Parts Change Information

SUBJECT → GR/FR Screen Assembly Modifications

APPLIES TO: **GR, FR** PARTS COMPATIBILITY: **Not Compatible** **DOCUMENT NO: 20392**

1. A4/B4 drum

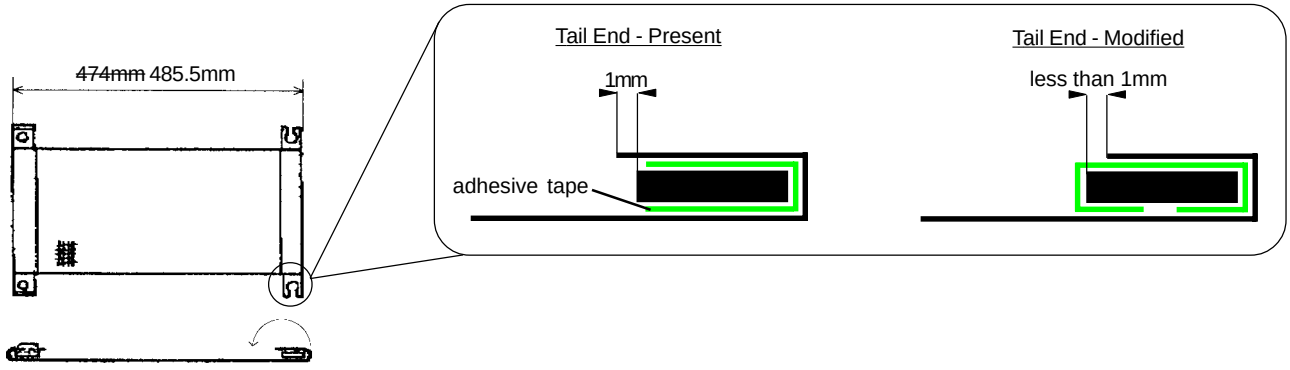
Summary: Improvements have been made to A3 and B4 screen assemblies to prevent master wrinkle and elongation. Details are as follows:

a) The double-sided adhesive tape located at the screen assembly tail end has been repositioned.
   b) The screen is now longer so that the tail end can be rolled over when installed.
